ISSUE: Permit to Demolish/Capsulate (partial) and Certificate of Appropriateness for alterations

APPLICANT: 910 King Street, LLC

LOCATION: Old and Historic Alexandria District
910 King Street

Figure 1: Revised proposal for roof deck railing and stair enclosure

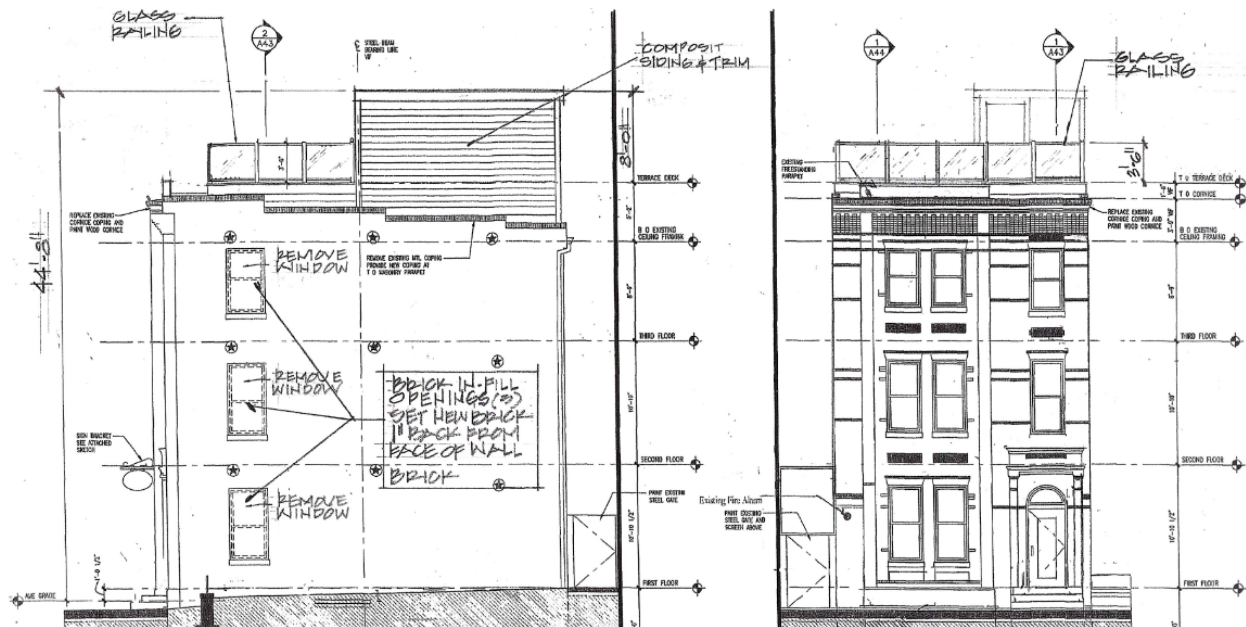
As noted above, the Board's comments regarding the proposed roof deck were largely related to the visibility of the stair enclosure and the guardrails. By switching from the decorative metalwork to the glazed railings, the extent of the roof deck will now be minimally visible from the public right of way. It should also be noted that the Board has approved the use of glazed guardrails or cable railings on numerous roof decks throughout the district, including the cable rails at 710 King Street. The *Design Guidelines* state that "Roof decks should be constructed so that they do not interfere with the historic roof-line of a building." As has been previously noted by the Board, the use of glazed guardrails on a roof deck do not detract from the historic roof-line of a building. Staff notes however, that there is little detail regarding the construction of the guardrails. Staff recommends that the applicant work with staff to specify a glazed railing with a simple and minimally visible top rail and no visible vertical posts.

In response to Board members concerns regarding the height of the proposed stair enclosure, the applicant has reduced its height from 9'-0" to 8'-0" above the top of the roof deck. When combined with the reduction in the height of the roof deck above the roof surface, the top of the stair enclosure is currently approximately 2'-0" lower than originally proposed. The exterior of the enclosure is being proposed to be composite siding; however there is no specific product indicated.

Staff finds that the applicant has made revisions to the roof deck and stair enclosure construction that have served to reduce the visible height above the existing roof surface. The location of this site directly adjacent to a parking lot provides for a high level of visibility for any rooftop structures, similar to a building located at the corner of a block. The height of the stair enclosure is limited by code required clearances for the entry door and a height of 8'-0" is close to what is required for the interior clearance. Staff finds that the height has been reduced as much as functionally possible and that if the Board determines that its visibility is still intrusive on the historic roof line of the building, the applicant should explore modifications to its location or shape. Staff recommends that the applicant work with staff on the proposed shape and location for the stair enclosure as required to minimize its visual impact on the existing building.

1. The applicant will work with staff to specify a glazed railing with a simple and minimally visible top rail and no visible vertical posts.
2. The composite siding at the stair enclosure will have a smooth finish.
3. For the window infill at the west elevation, the applicant will work with staff to find a brick that is similar in color to the adjacent wall and the bonding pattern be similar to the adjacent wall.
4. The applicant will work with staff to explore ways in which the massing of the stair enclosure can be diminished or its visibility limited.

Figure 3: 1941 Sanborn Map showing structure at front of lot at 912 King Street

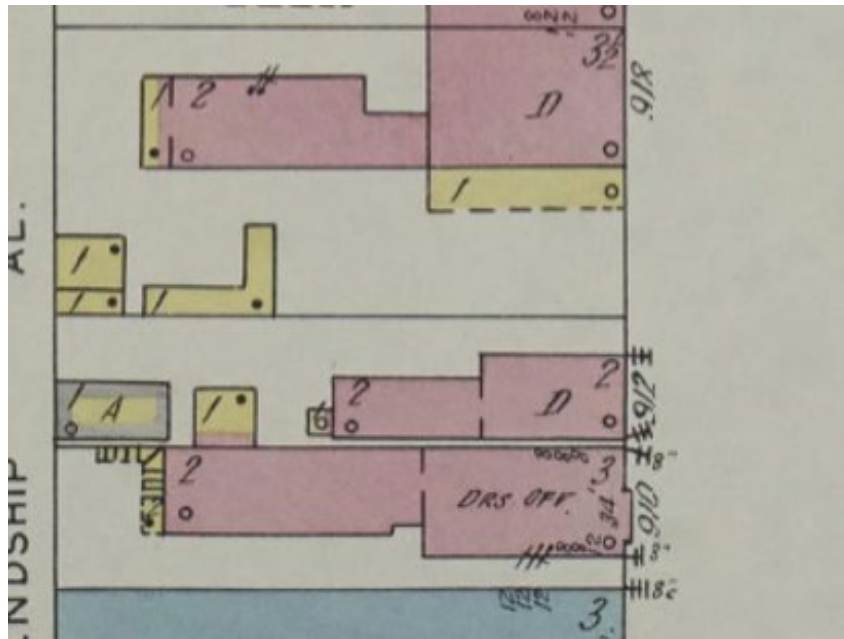
The analysis of the standards indicated above relate only to the portions of the wall areas proposed for demolition/capsulation. In the opinion of staff, none of the criteria for demolition and capsulation are met and the Permit to Demolish/Capsulate should be granted. The area of the roof to be demolished dates from 1892 and is not of unique construction or materials. The windows on the west elevation that are to be enclosed are not original to the building, having been added upon the demolition of the structure previously located at 912 King Street, sometime after 1941 (Figure 3). As such, staff recommends approval of the Permit to Demolish/Capsulate (partial).

BAR Submission
ROOF PLAN
ROOF TERRACE
PLAN

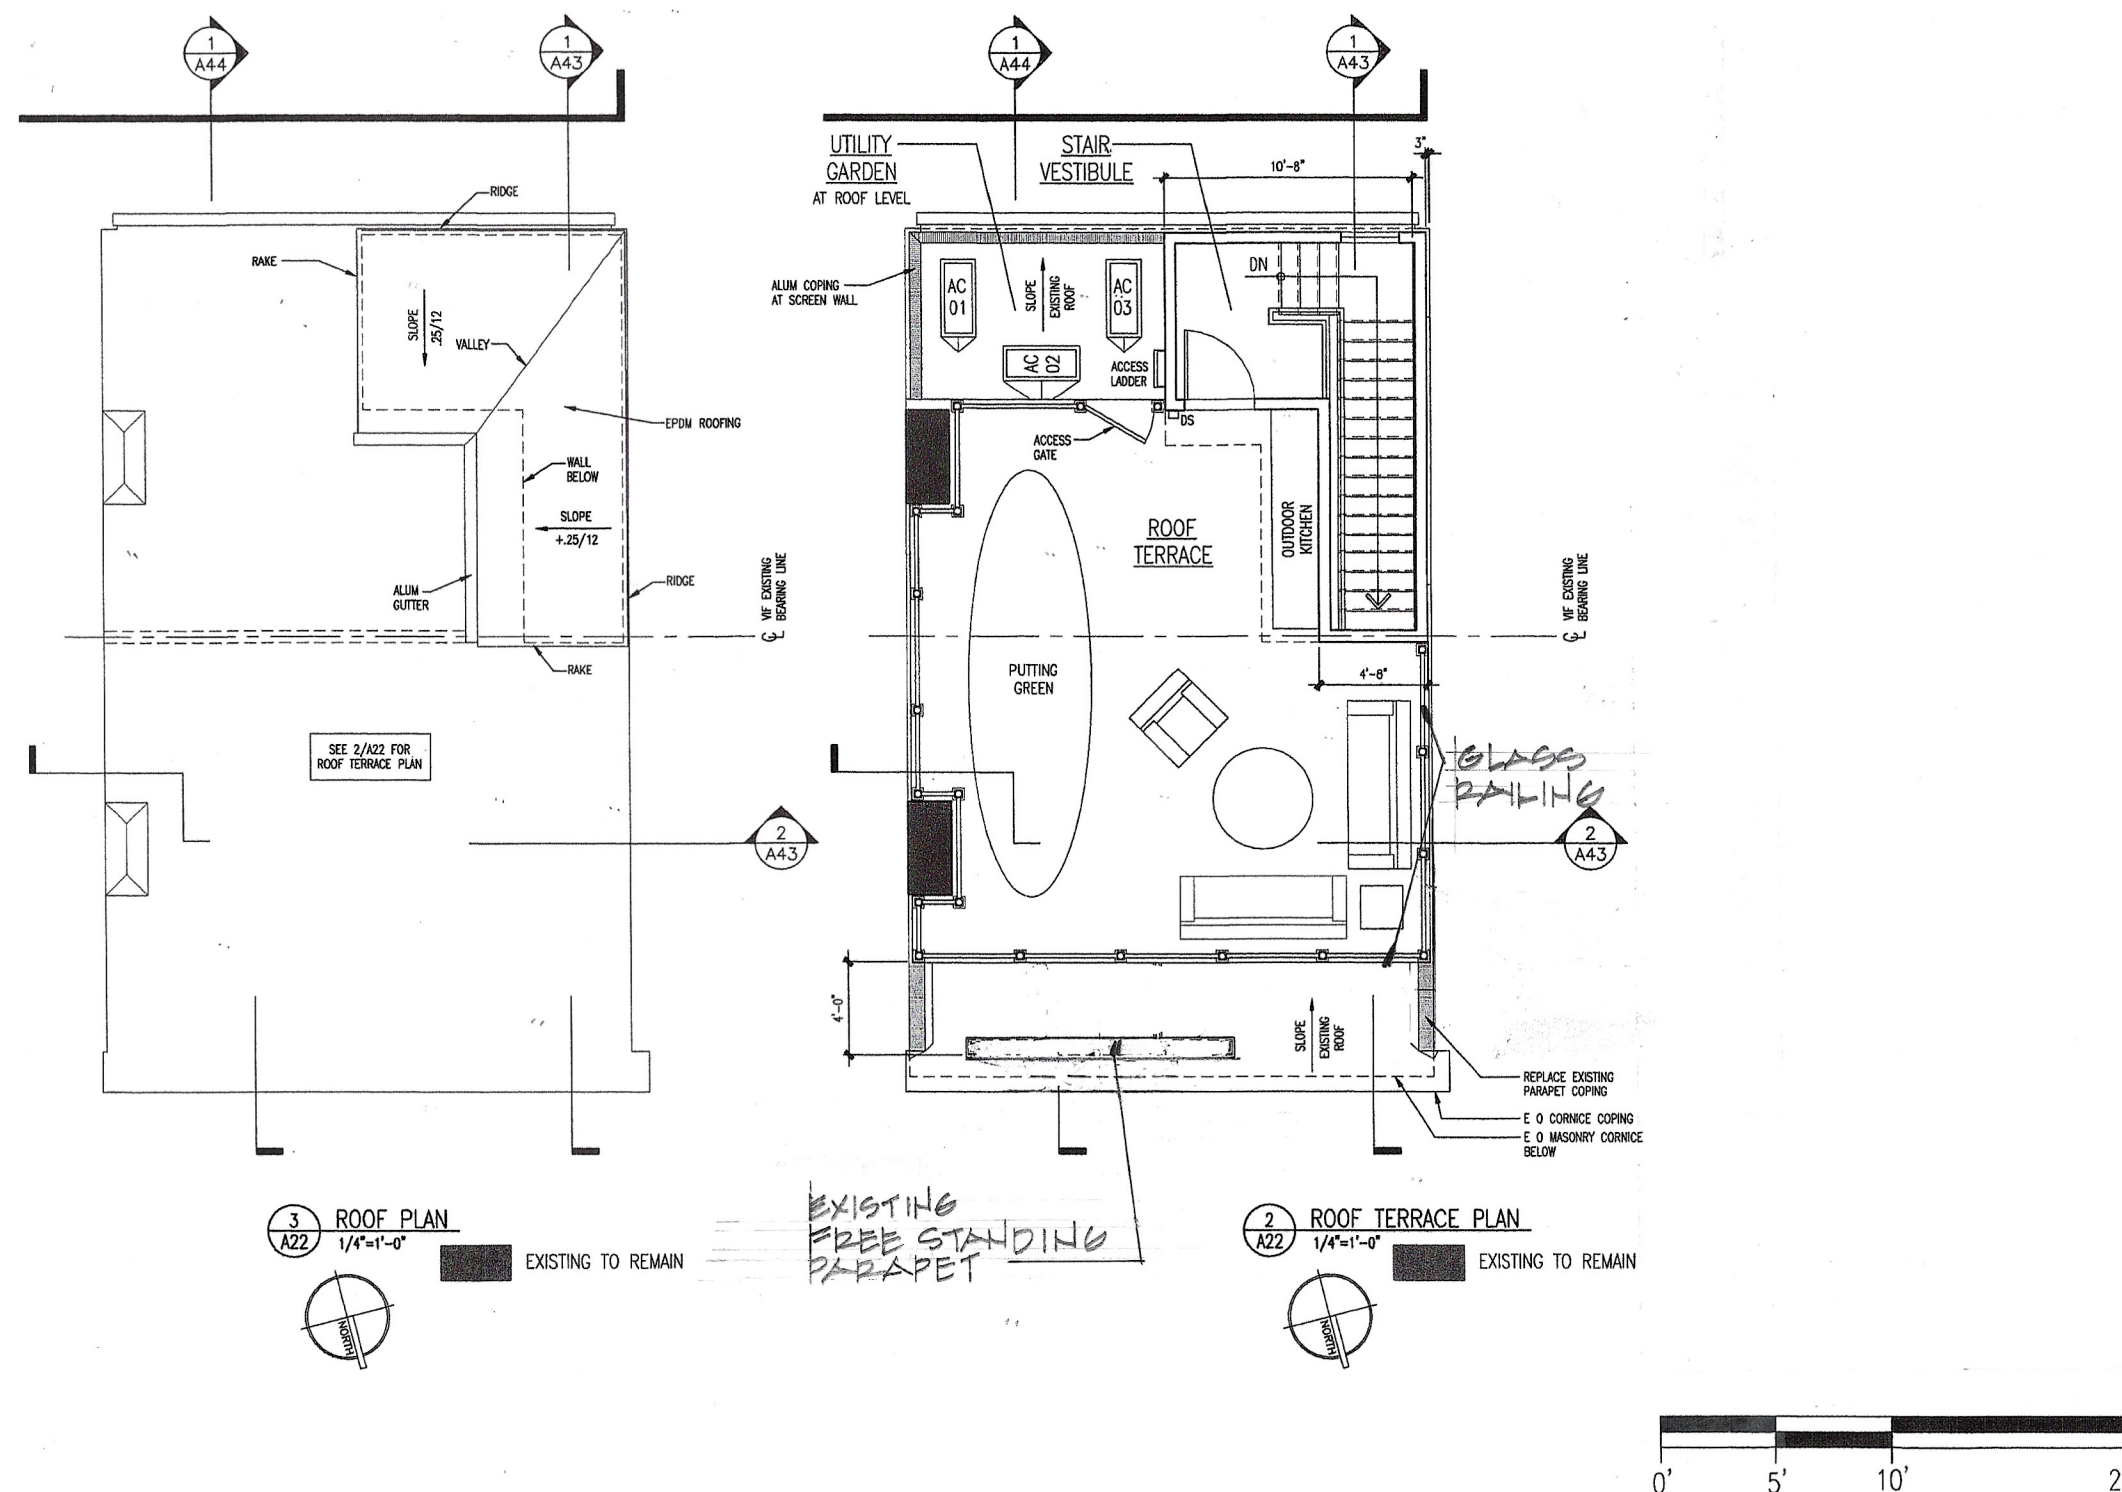
- Board members stated that the proposed roof deck railing and stair enclosure are too visible from the public right of way and are not appropriate for the building.
